Work Order ID 74573

Item Name: Crosstube Turning Detail

DRAWING NO. D212-664-147	TITLE CROSSTUBE ASS'Y (205 LOW FWD)	REV. B	DART AEROSPACE LTD ENGINEERING ORDER		D.E.O. NO. D212-664-147-B-1	SHEET NO. SHEET 1 OF 1	SCALE NTS
DRAWN <i>q</i>	CHECKED <i>ASS</i>	MFG. APPR. <i>VB</i>	APPROVED <i>WJ</i>		DE APPR. <i>H</i>		
DATE 11.07.15	DATE 11.07.20	DATE 11.07.21	DATE 11/07/21		DATE 11.07.21

REPLACE MAGNOBOND WITH PROSEAL.

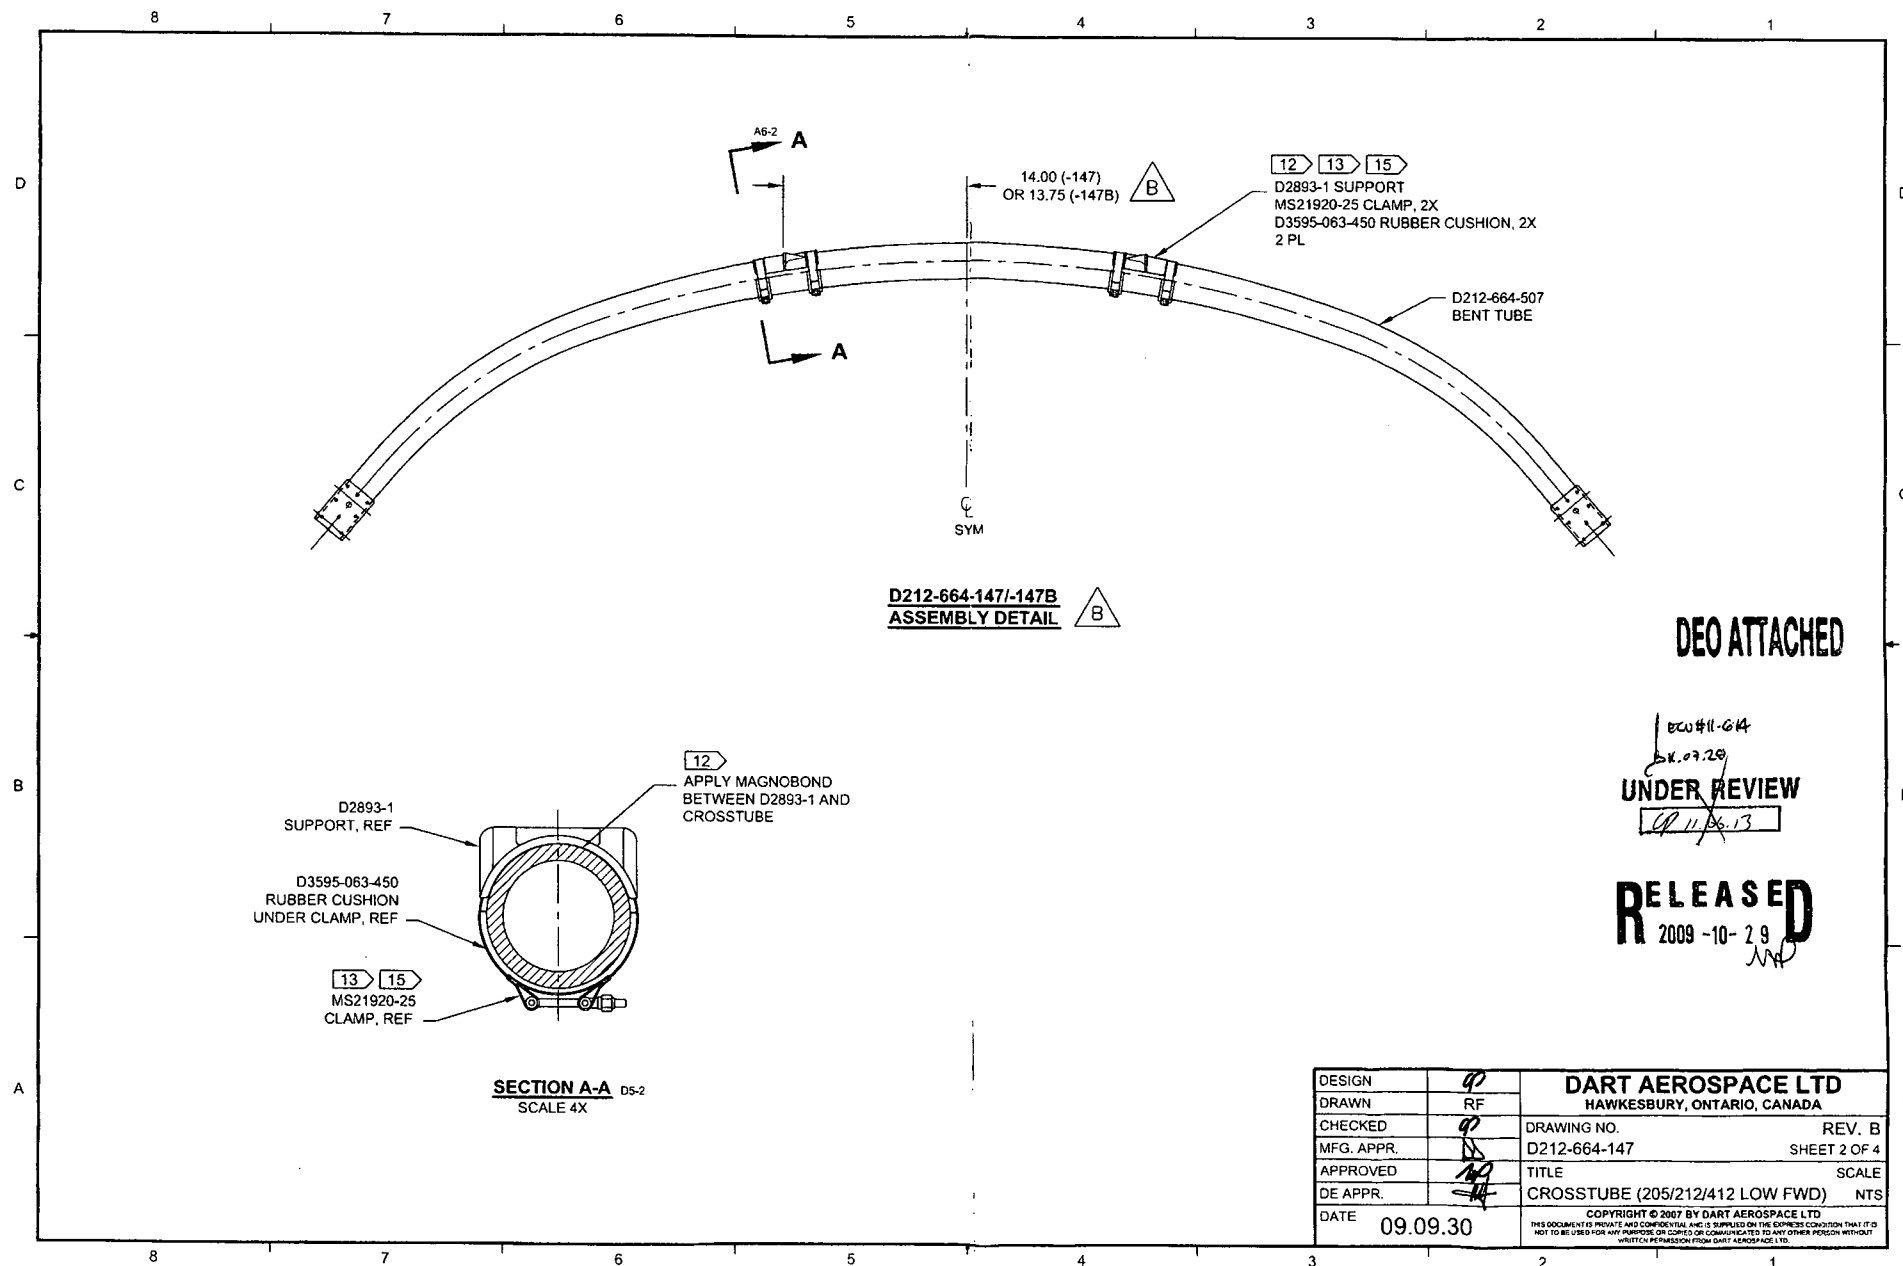
NOTE 12 & 15, SHEET 1 IS AMENDED AS FOLLOWS:

12) TO INSTALL D2893-1 SUPPORT: ABRASE MATING SURFACE OF SUPPORT AND CROSSTUBE WITH 180-GRIT SANDPAPER AND REMOVE RESIDUE WITH MEK (OR EQUIVALENT). APPLY A 0.04" TO 0.07" THICK LAYER OF PROSEAL 890 CLASS B-2 (OR AMS-S-8802 CLASS B-2) SEALANT TO MATING SURFACE OF SUPPORT.

15) TORQUE CLAMPS 80 TO 100 IN-LB. ENSURE AT LEAST 1.5 THREADS SHOWING IN SAFETY AND THAT NUT HAS NOT BOTTOMED-OUT AFTER TORQUING. **PRIOR TO PACKAGING, RE-CHECK TORQUE ON CLAMPS AFTER PROSEAL 890 SEALANT HAS CURED FOR 72 HOURS.**
